# HIGHLAND PLANNING COMMISSION AGENDA

# PLANNING COMMISSION AGENDA REPORT ITEM #3a

**DATE:** August 26, 2025  
**TO:** Planning Commission  
**FROM:** Rob Patterson, City Attorney/Planning & Zoning Administrator  
**SUBJECT:** Highland Town Plaza Lot 3 Site Plan and Architecture Review  
**TYPE:** Land Use (Administrative)

1. Highland Town Plaza - Lot 3 - Review Comments - 2025.08.21 (Stipulation)
2. Project Narrative
3. 1. Highland Town Plaza Lot 3\_Site Plan
4. 2. Highland Town Plaza Lot 3\_Landscape
5. 3. Highland Town Plaza Lot 3\_Building Elevations and Details
6. 4. Highland Mo'Bettahs TGS 20250328 Signed

LEI

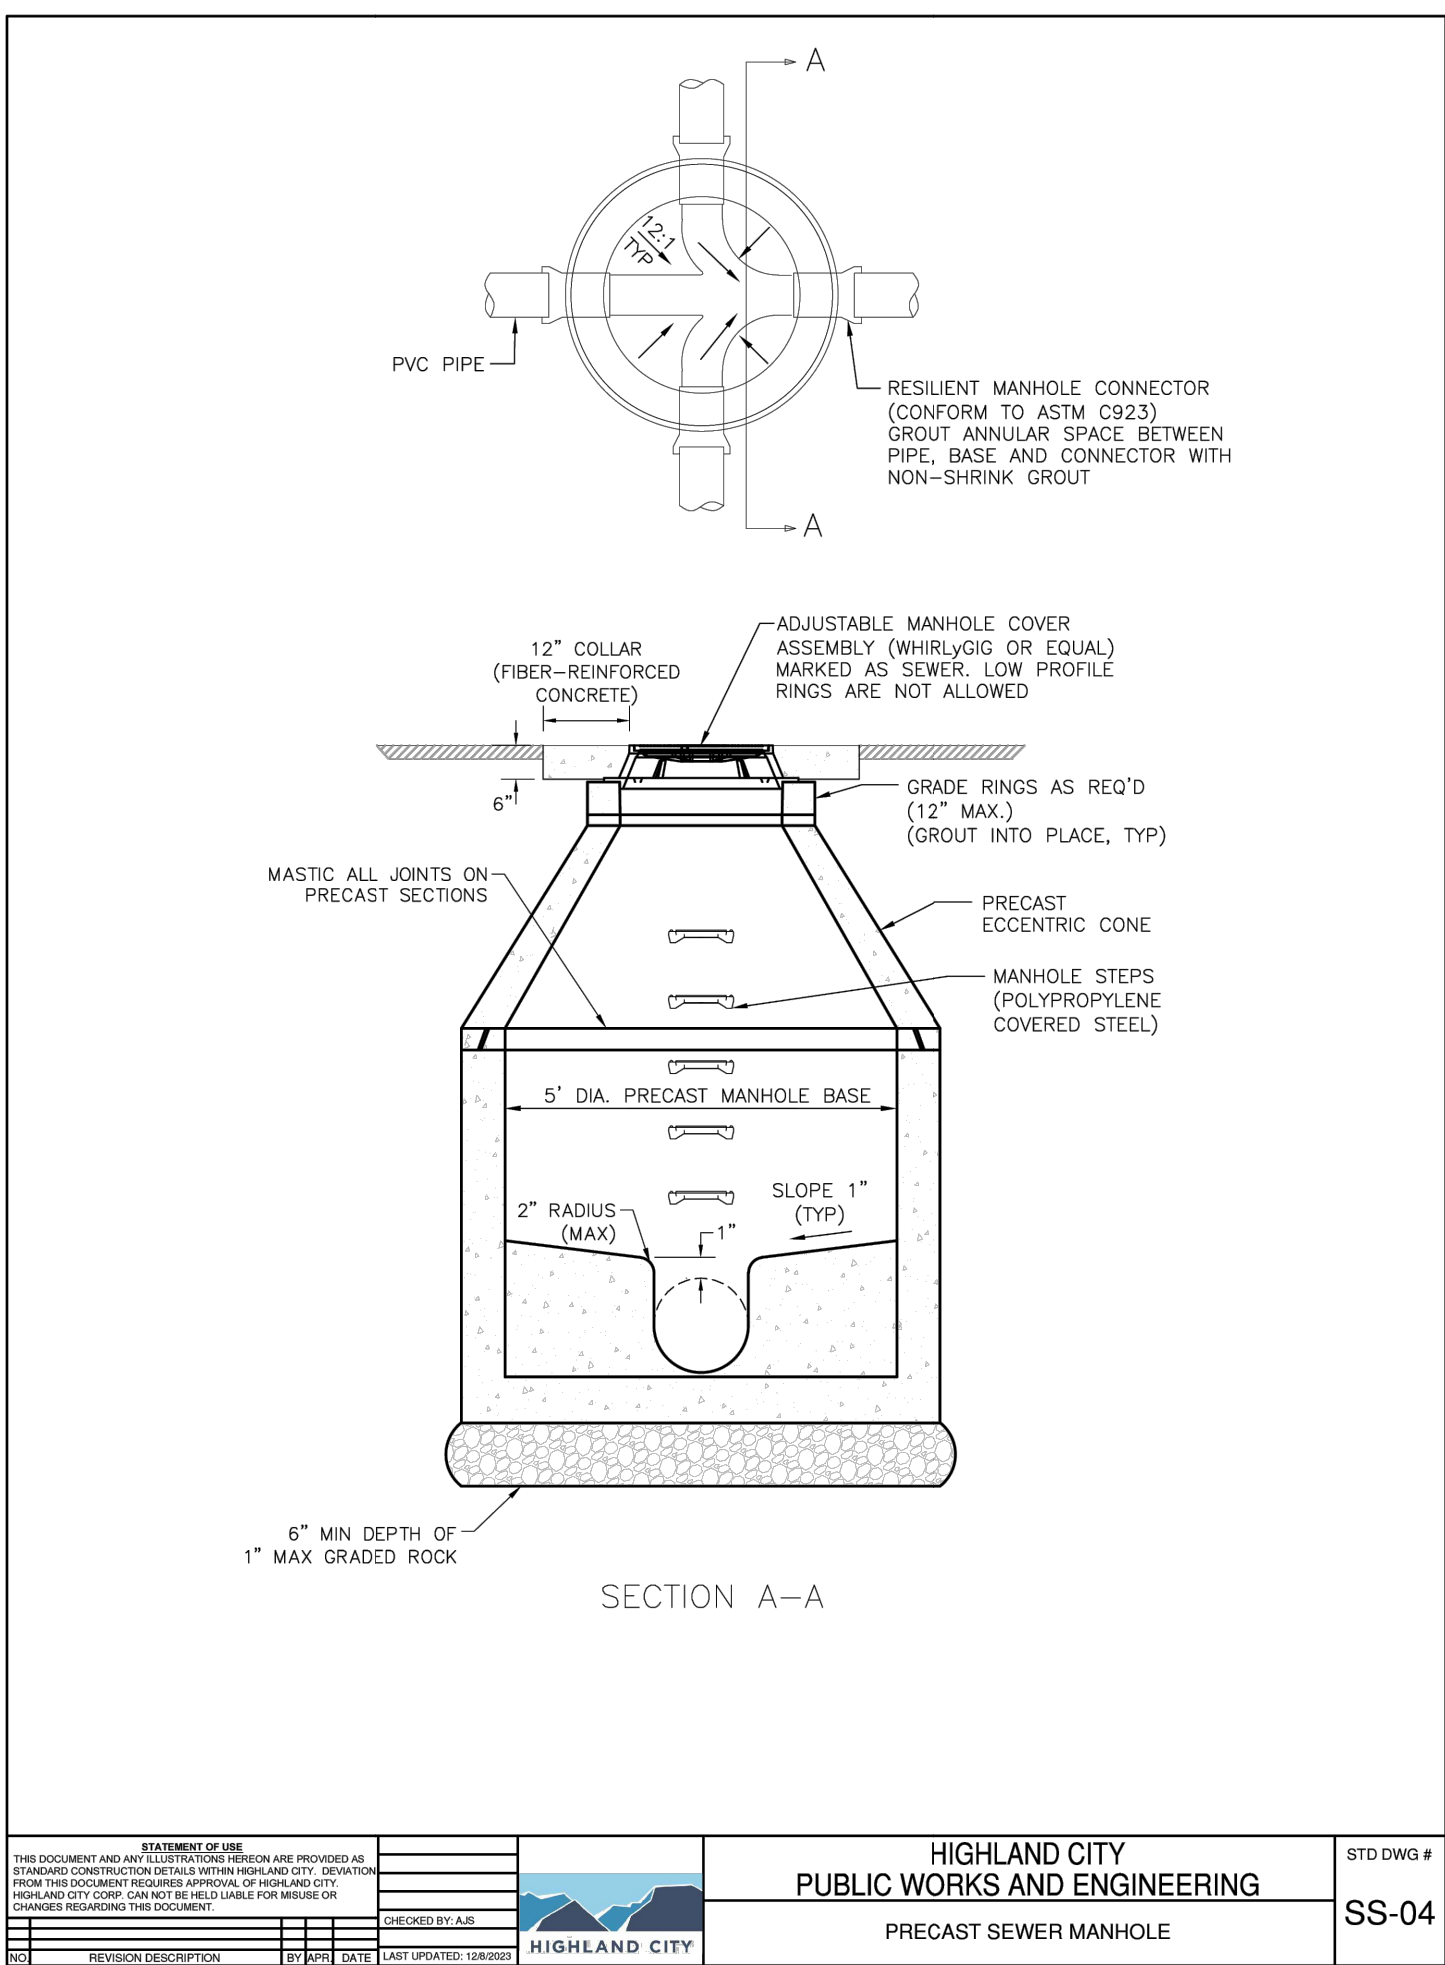
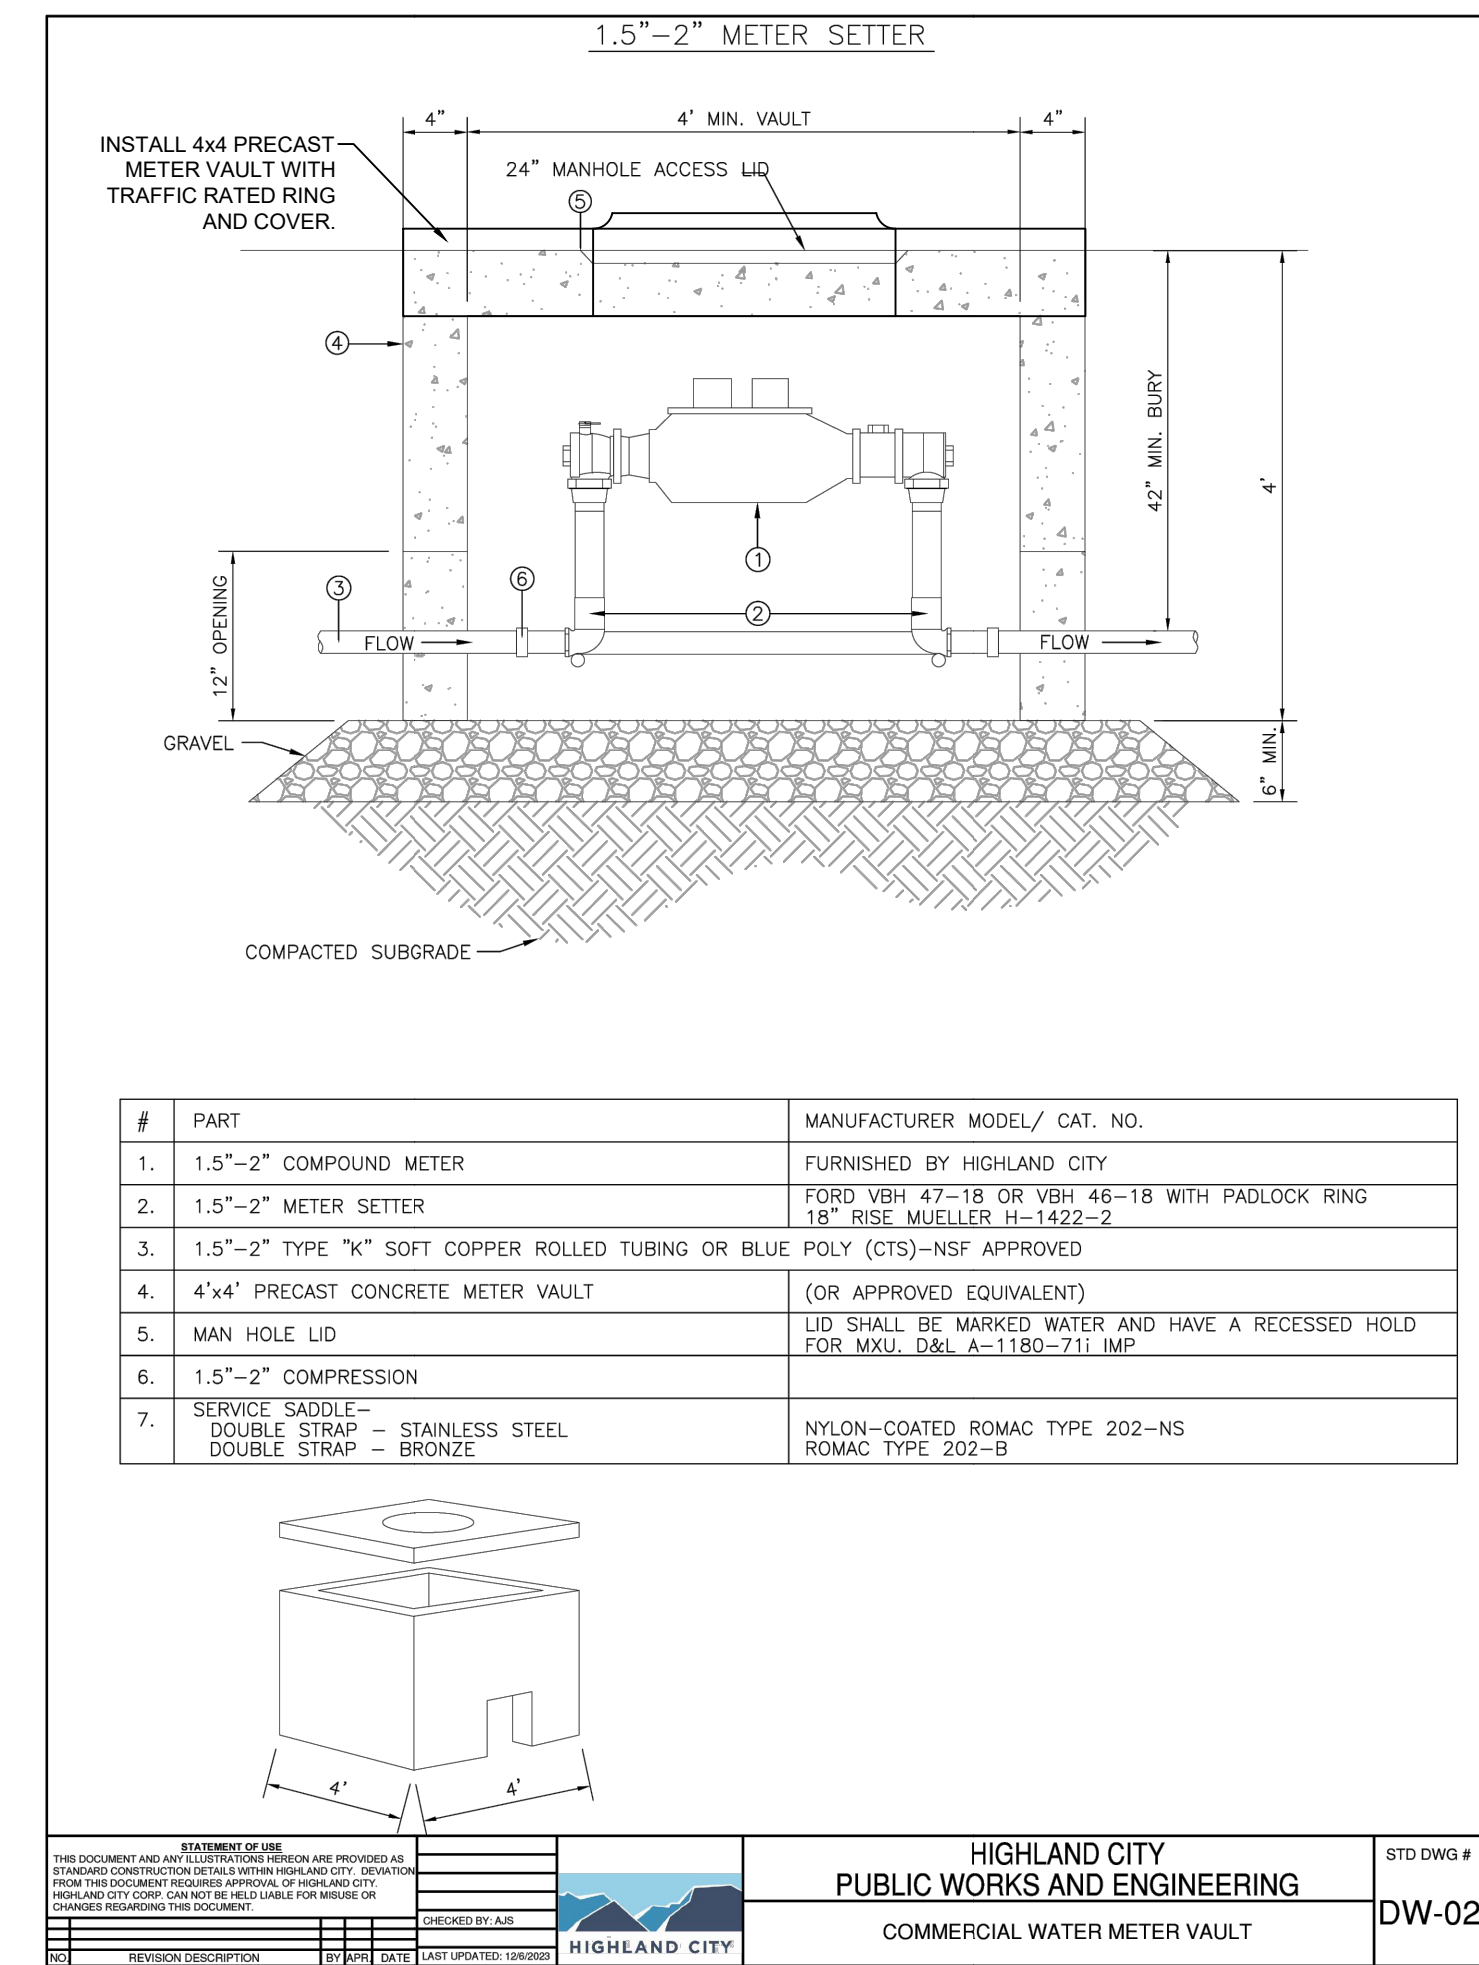
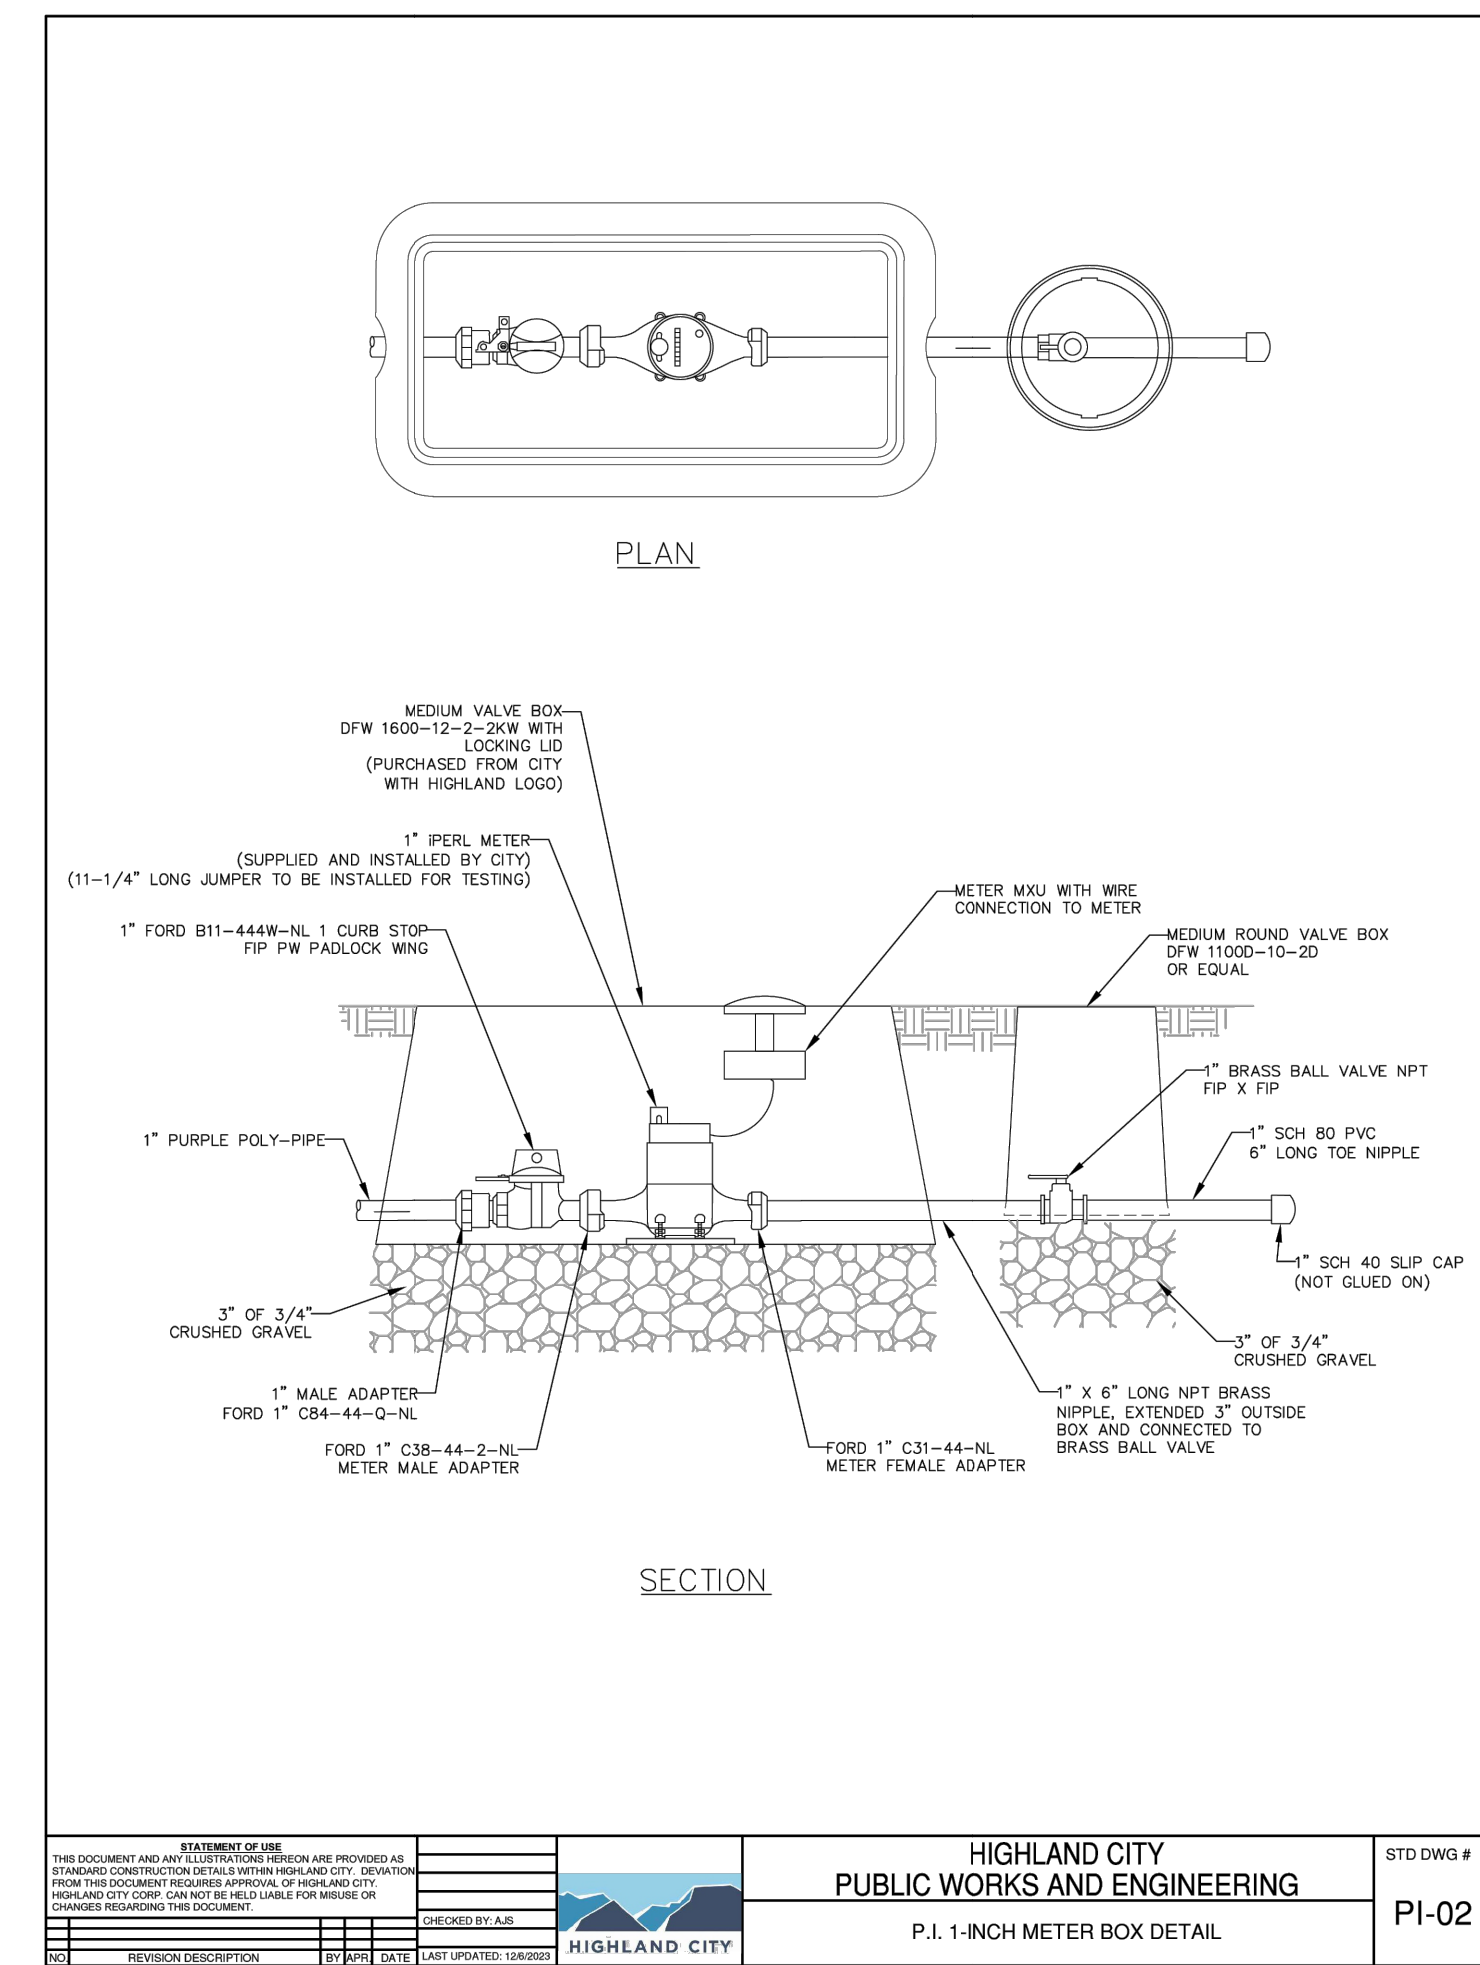
**Sheet 601-602 (Details):**

- 15. Consider providing full sheets for SD system details.
  - a. A full sheet of the SD system construction details is recommended.
